## 15-708 Installing preglow time relay with modified ventilation

Since September 1981 a preglow time relay with modified ventilation is installed for quick-start preglow system. The part number has not been changed.

Modified preglow time relay

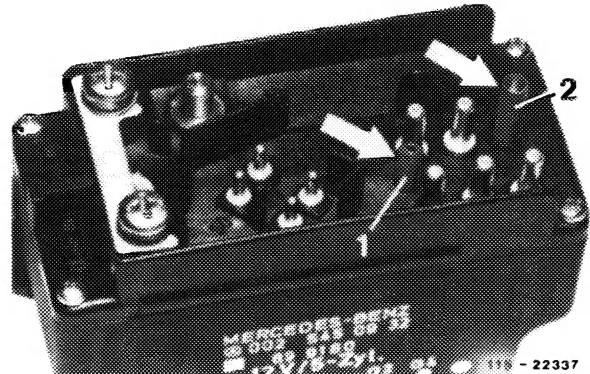
In the modified version of the preglow time relay, ventilation proceeds via coding pin (1). The coding pin (2) is also longer as before and the 5-pole coupler has been designed in such a manner that the ventilation is covered. In the former preglow time relay ventilation proceeded through a bore in housing.

5-pole coupler

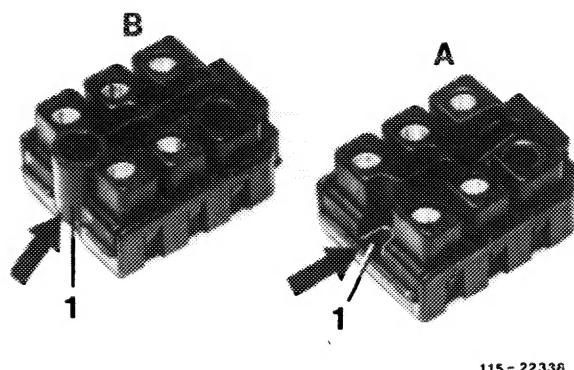
The modified preglow time relay can also be installed in vehicles prior to September 1981. In such a case, the modified 5-pole coupler must also be installed, since otherwise moisture may enter the relay.

Upon installation of the new relay, convert coupler of harness to new ventilation.
